Access Compliance Report

Public Rights-of-Way (Curb Ramps)

| Intersection ID: 14493 | Main Street: CARONIA_ST | Cross Street: CLANTON_RD | Location: SW |
| ADA ID: 9BC236E71388 | Ramp Type: Directional1 | Initial Pass/Fail: Fail | Overall Compliance: No |

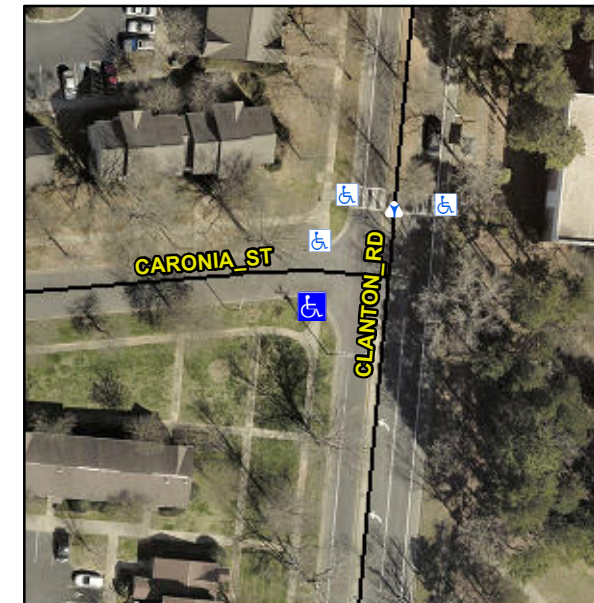
R304.2.2

| Compliance | Description | Data | Compliance | Description | Data |
|------------|-----------------------|-------|------------|-----------------------------|------|
| No | Ramp Slope (%) | 11.6 | N/A | Grade Break XSlope (%) | 0.0 |

Remove & Replace Entire Ramp.
